10/715,376

Office Action Summary

DETAILED OFFICE ACTION

FIG. 1*FIG. 2*10

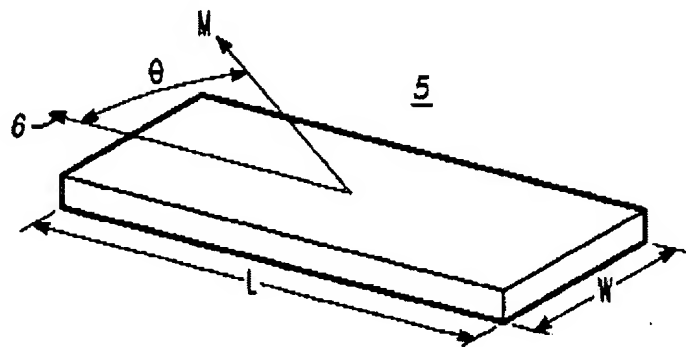
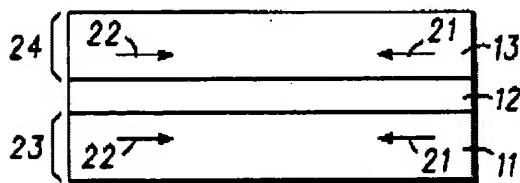
Chen (fig 1,fig2,fig 3, column 2 lines 40-44,column 4 line 40) discloses magnetic memory element, comprising: a plurality of magnetic layers, at least one of the plurality of magnetic layers (fig 3 layer 11,13) having a perpendicular magnetic anisotropy component and

FIG. 3

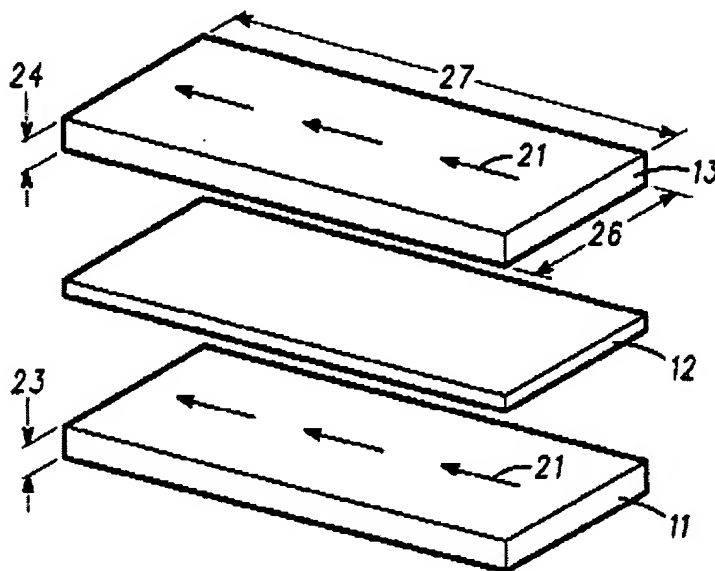
comprising a current-switchable magnetic moment; and at least one barrier layer(fig 3 layer 12) formed adjacent to the plurality of magnetic layers.

FIG. 9

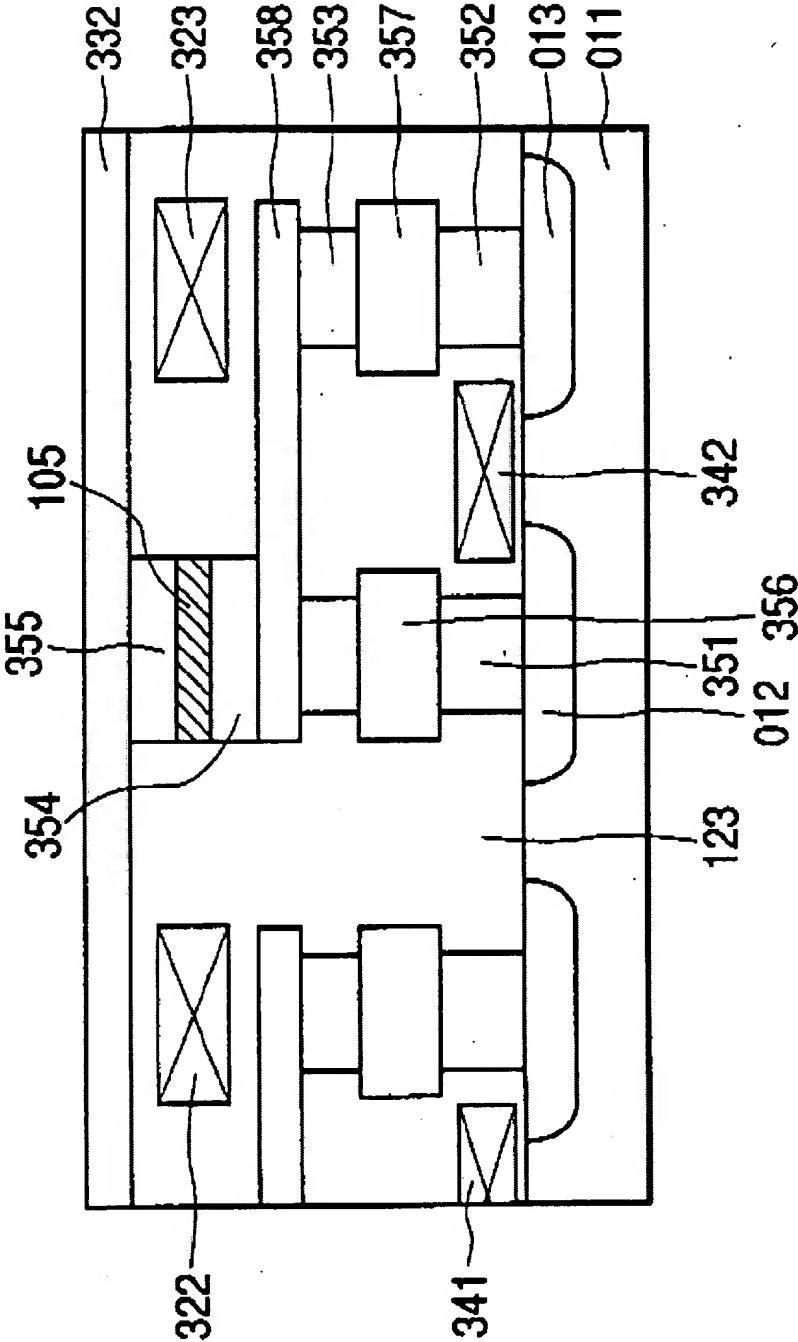
Ikeda (in the abstract , in fig 9) discloses a magnetic memory element, comprising: a plurality of magnetic layers (fig 9 layer 355,354), at least one of the plurality of magnetic layers having a perpendicular magnetic anisotropy component (the abstract lines 3-4) and comprising a current-switchable magnetic moment; and at least one barrier layer (fig 9 layer 105) formed adjacent to the plurality of magnetic layers. Noted that Ikeda discloses a tunneling magnetoresistive device (column 7 lines 5-6) therefore it is inherently a spin current switchable magnetic memory device. Noted that for most MRAM the switching effect is due to the switching of the write current of the word line either indirectly through the magnetic moment or directly through the MRAM stack.

Ikeda (in the abstract , in fig 9) discloses a magnetic memory element comprising: first and second leads (fig 9 layer 332 layer 358) ; and a pillar formed between said first and second leads, said pillar including said at least one barrier layer (fig 9 layer 105) and at least one magnetic layer (fig 9 layer 354 or 355) of said plurality of magnetic layers.
